SITE DEVELOPMENT PLANS

33 TOWNHOUSE UNITS

1525 & 1601 & 1603 & 1605 EAST 86TH STREET & 1604 & 1606 EAST 87TH STREET
BLOOMINGTON, MINNESOTA

REVISIONS	
04.28.26	CITY COMMENTS
05.12.26	REVISIONS
06.01.26	PLANS FINALIZED

4 C3 RETAINING WALL NOT TO SCALE

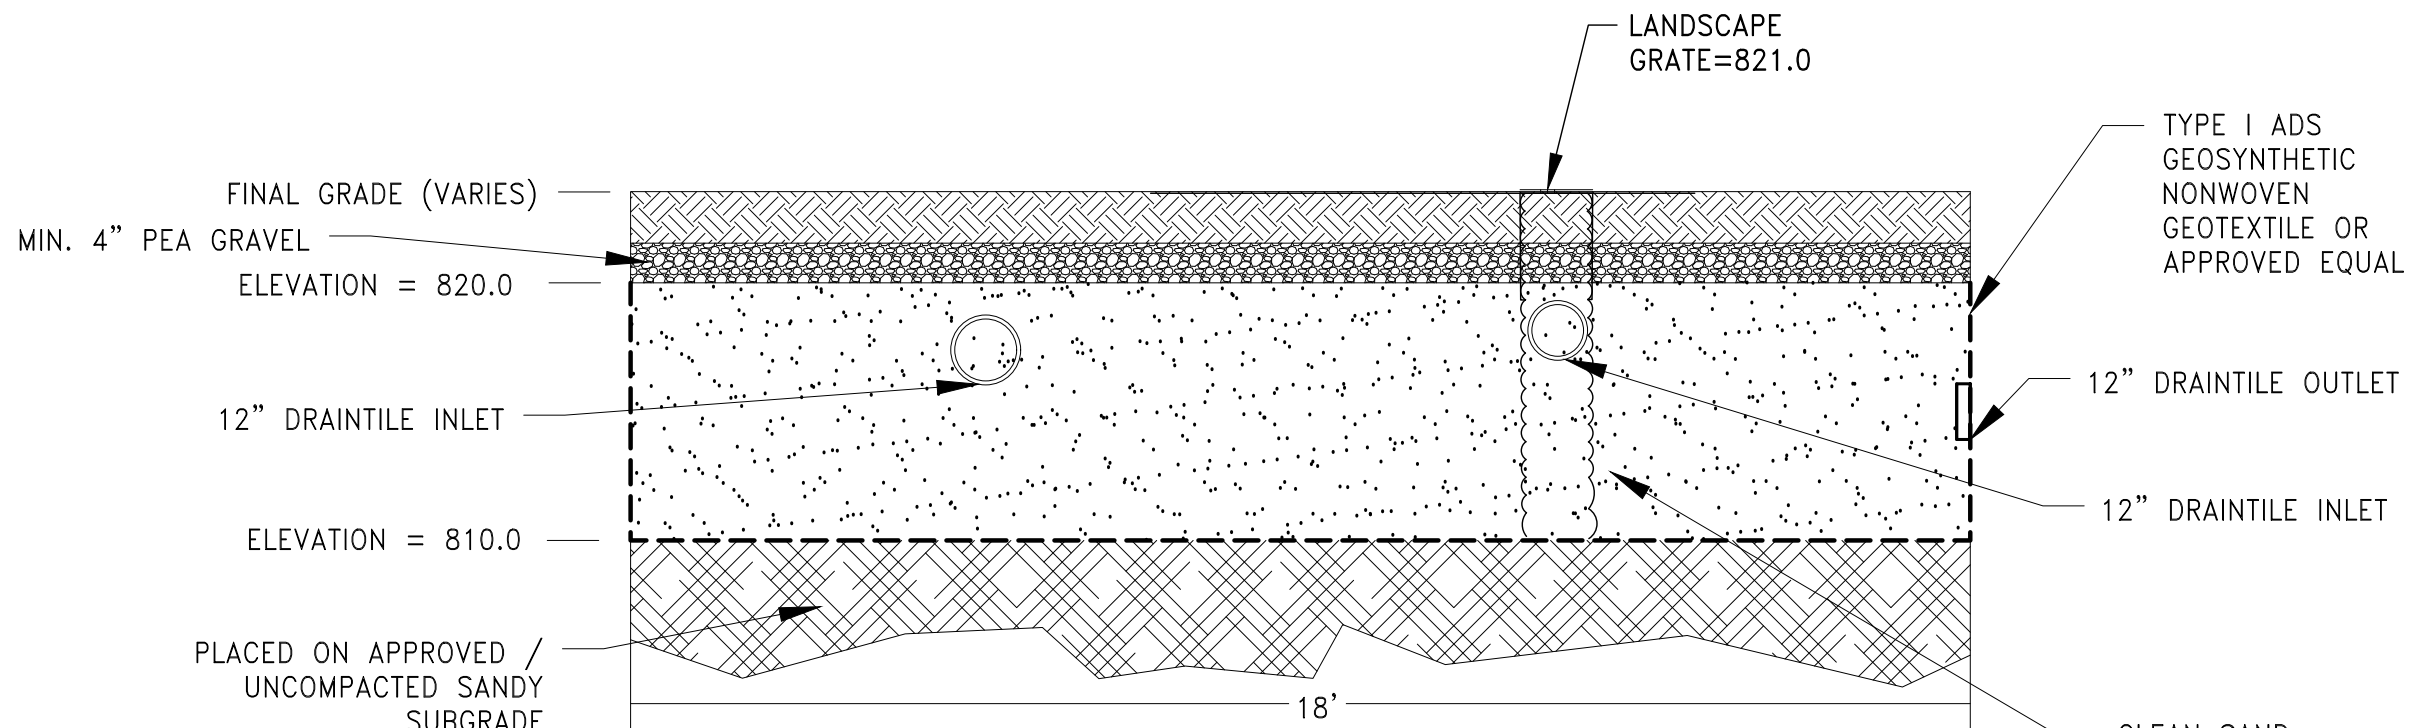
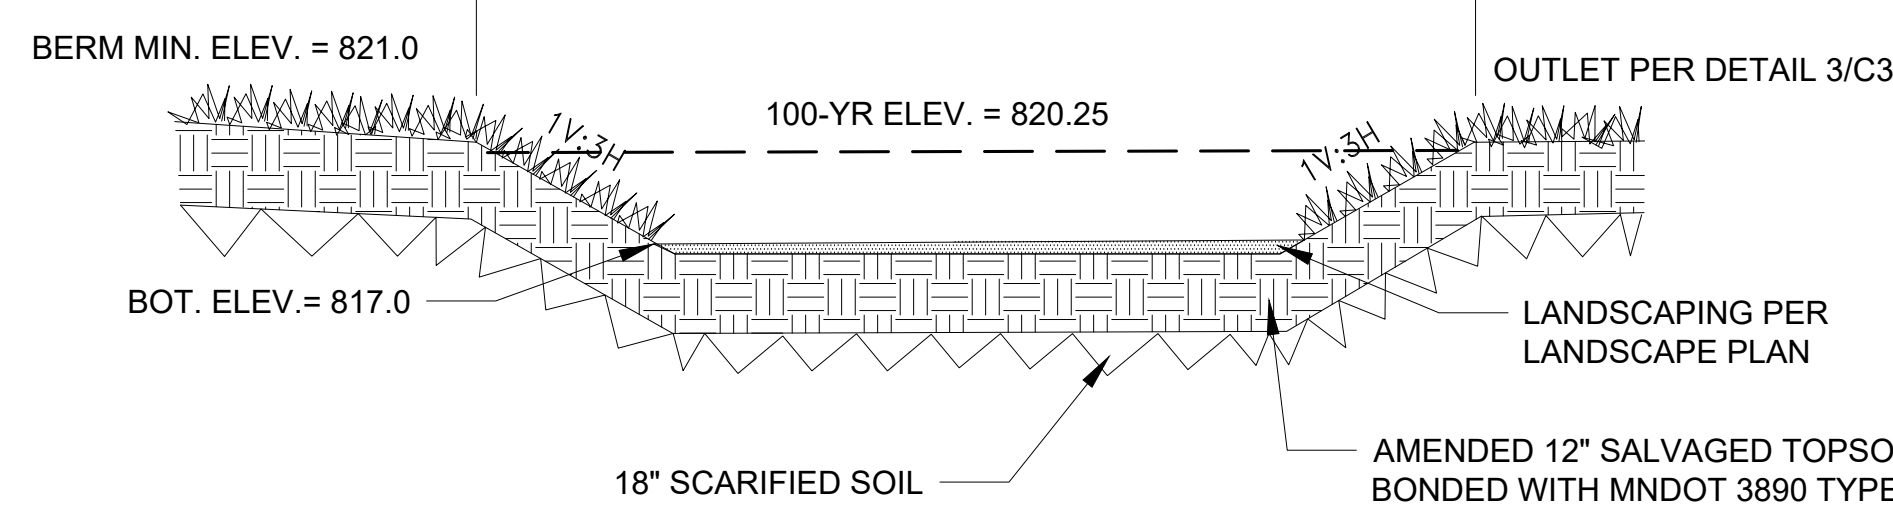
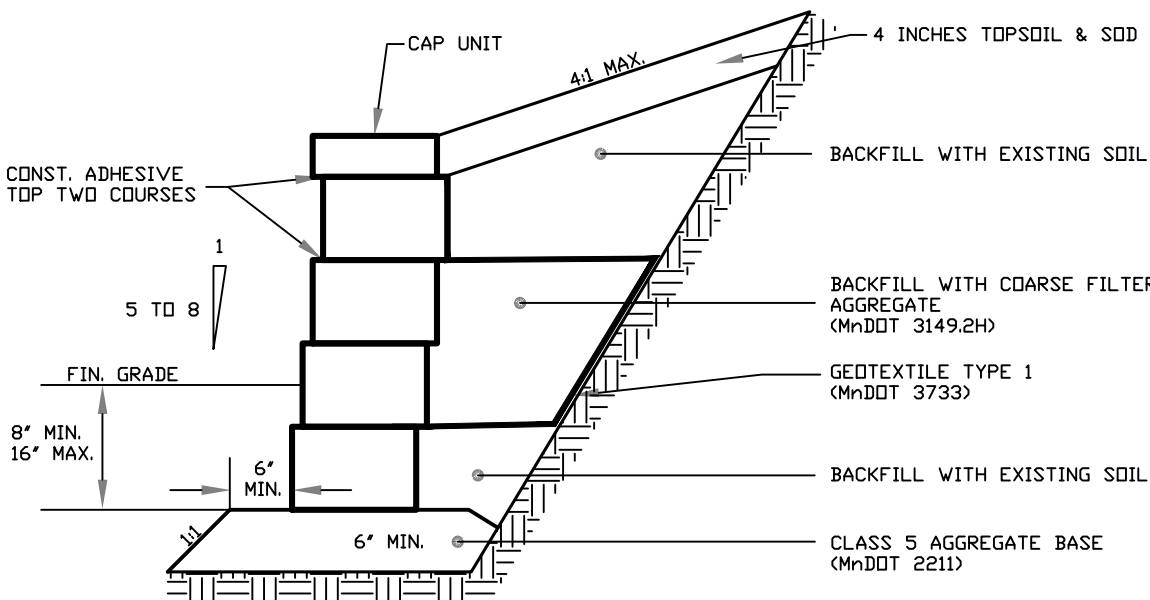
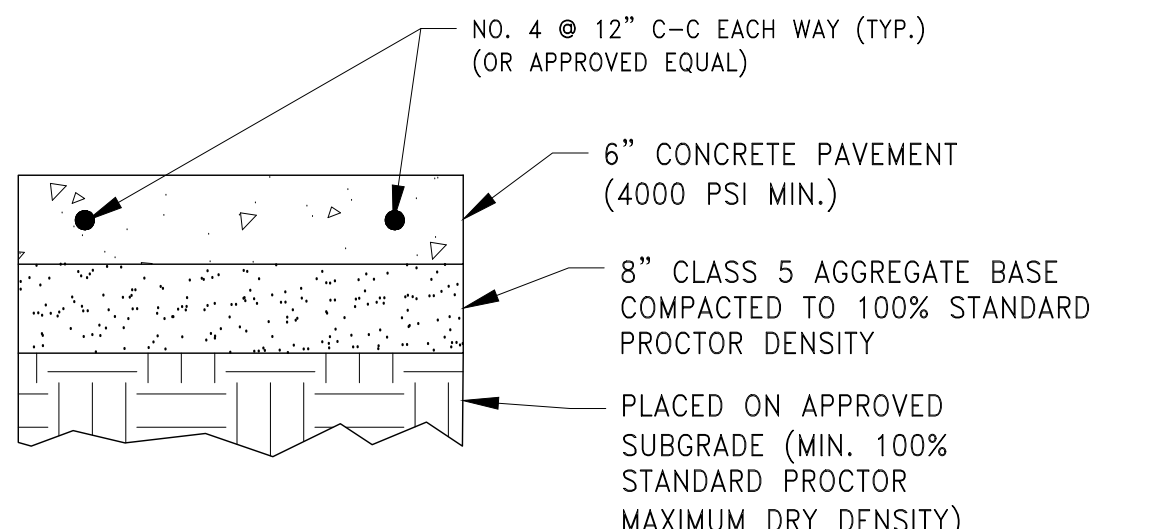
Engineer plans required for any retaining walls over 4 feet in height (measured from bottom of footing to top of wall).

EXISTING CONDITIONS & REMOVALS - NORTH

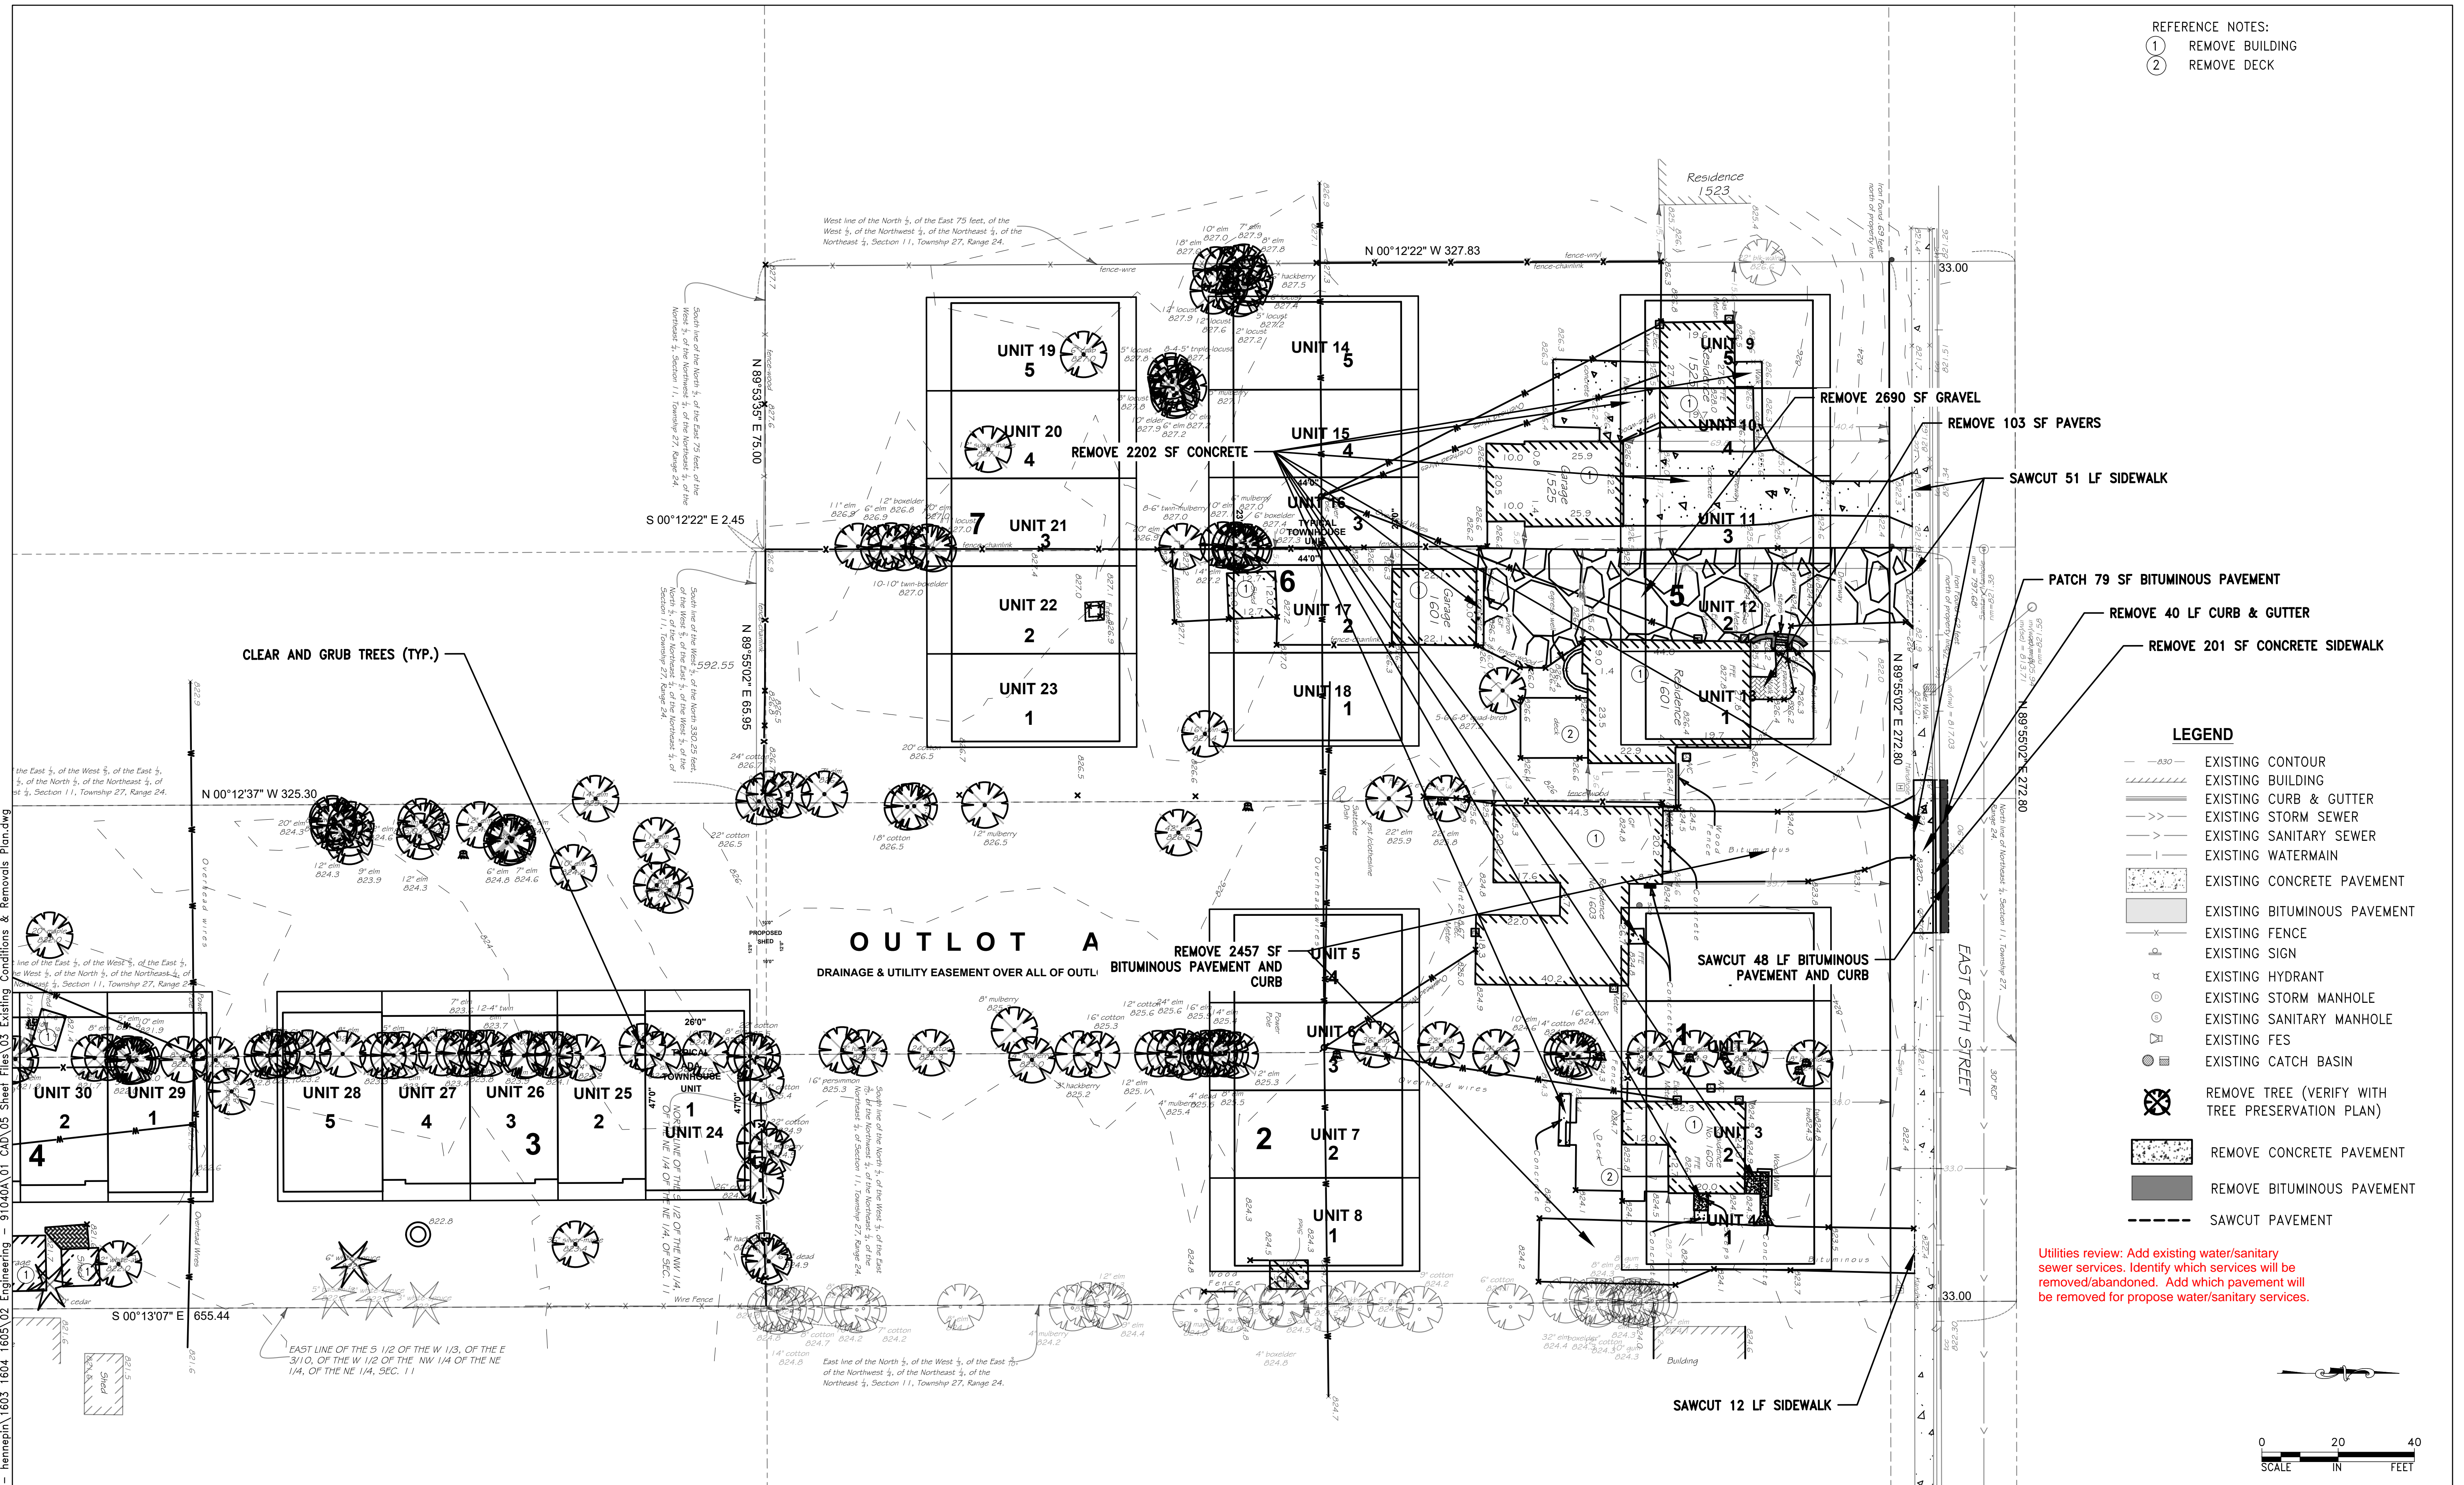
Utilities review: Add existing water/sanitary sewer services. Identify which services will be removed/abandoned. Add which pavement will be removed for propose water/sanitary services.
